ADDENDUM NO. 1

DATE OF ISSUANCE: July 24, 2026

PROJECT: City of New Albany Maryland Ave. Community Center
2020 Maryland Ave.
New Albany, IN 47150

ARCHITECT'S PROJECT NO.: 25-512.000

DOMESTIC WATER RISER
NO SCALE

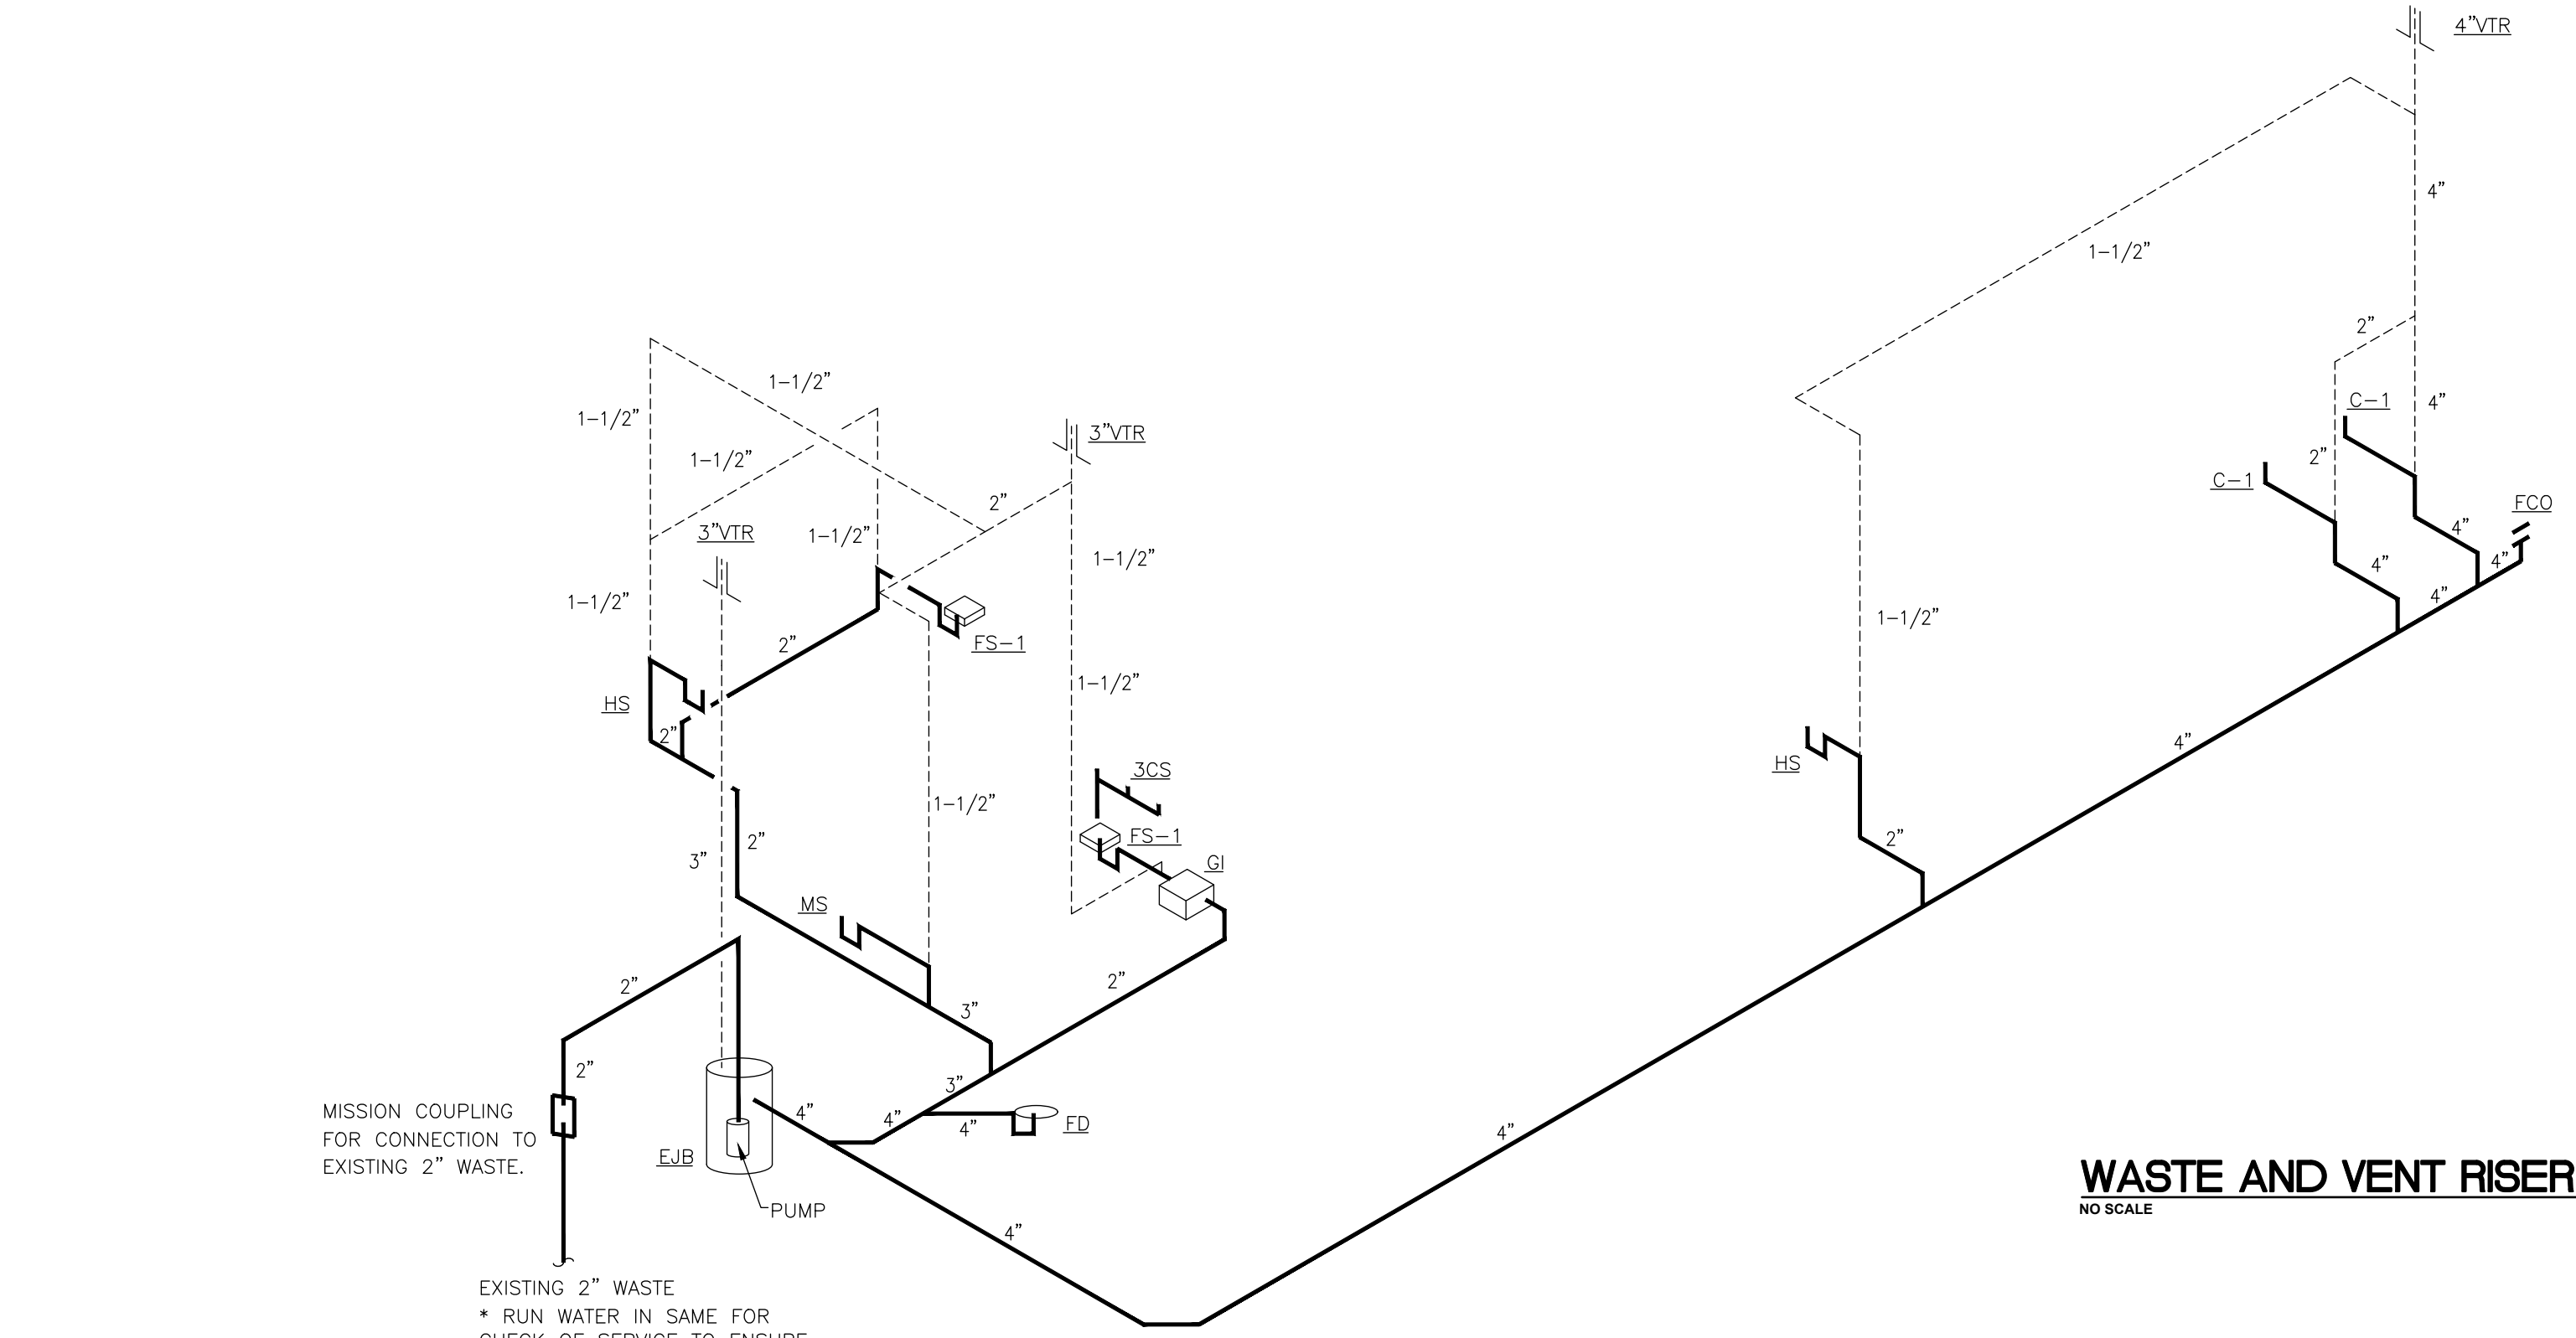
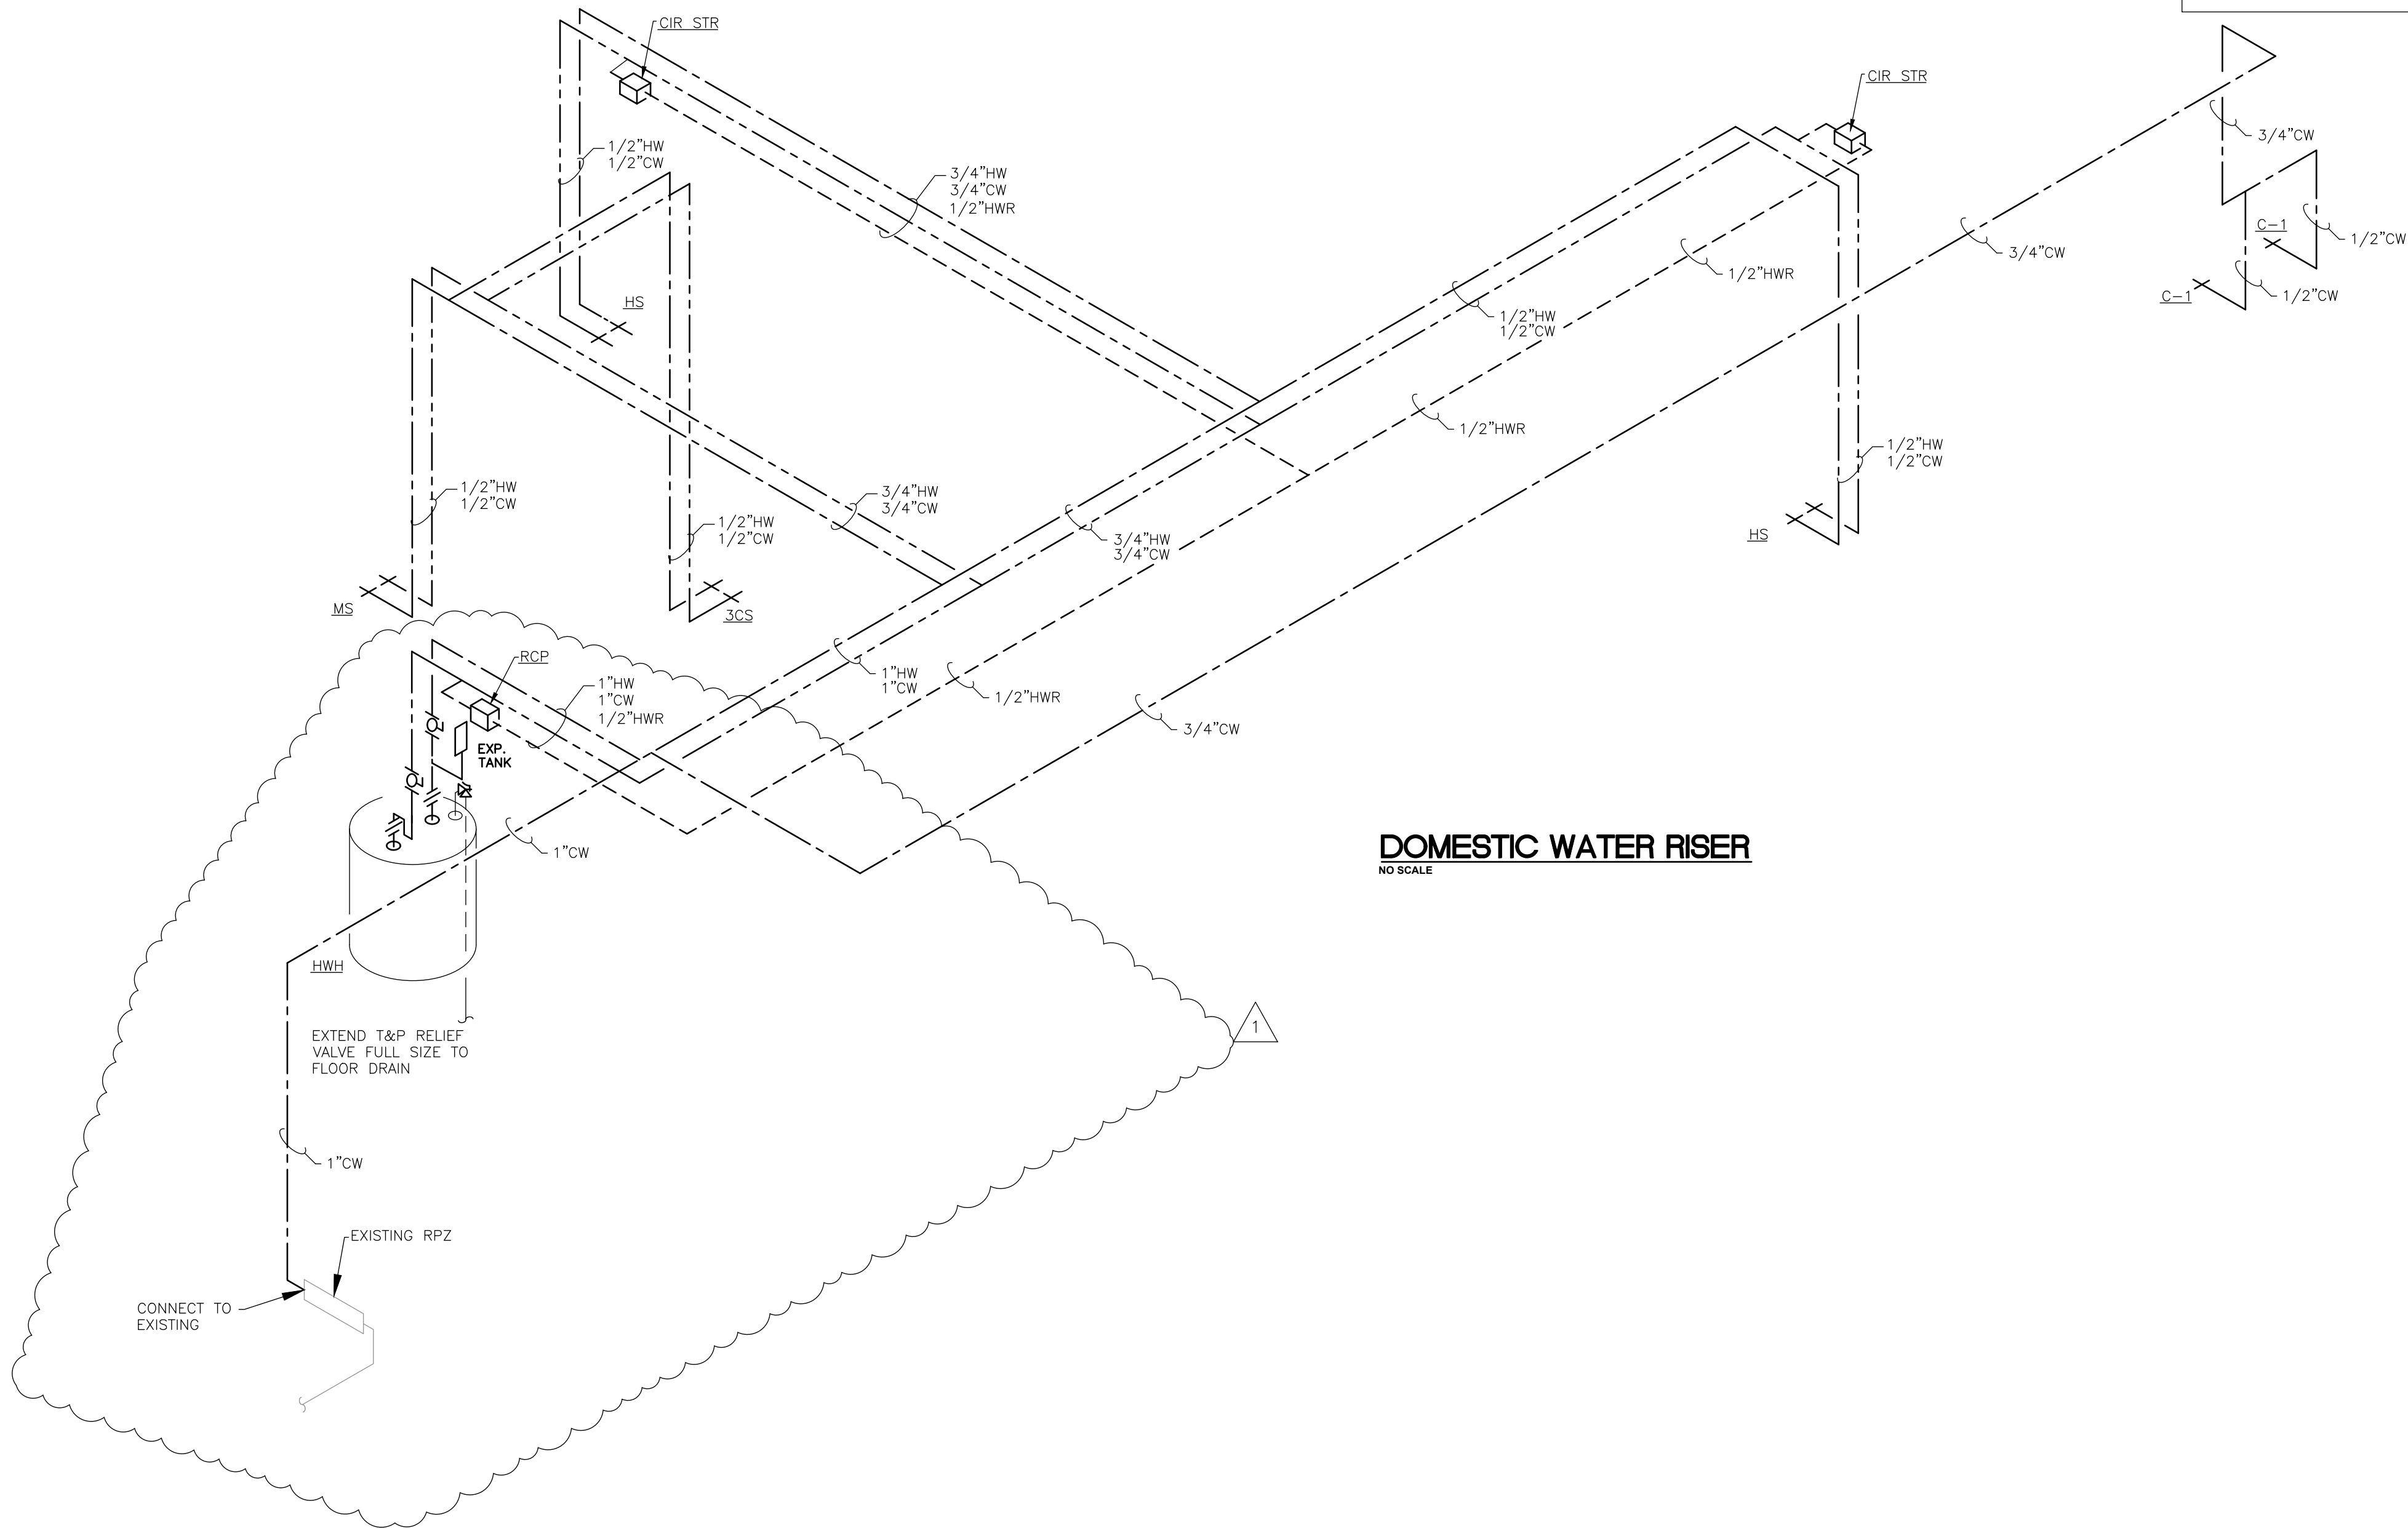
ADD-1 Item No. D-4 - Revised Existing Backflow Preventer Location

Sheets P 001 and P 101 dated 07/23/2026 have been revised to accurately represent the location of the existing backflow preventer in both plan and domestic water riser diagram.
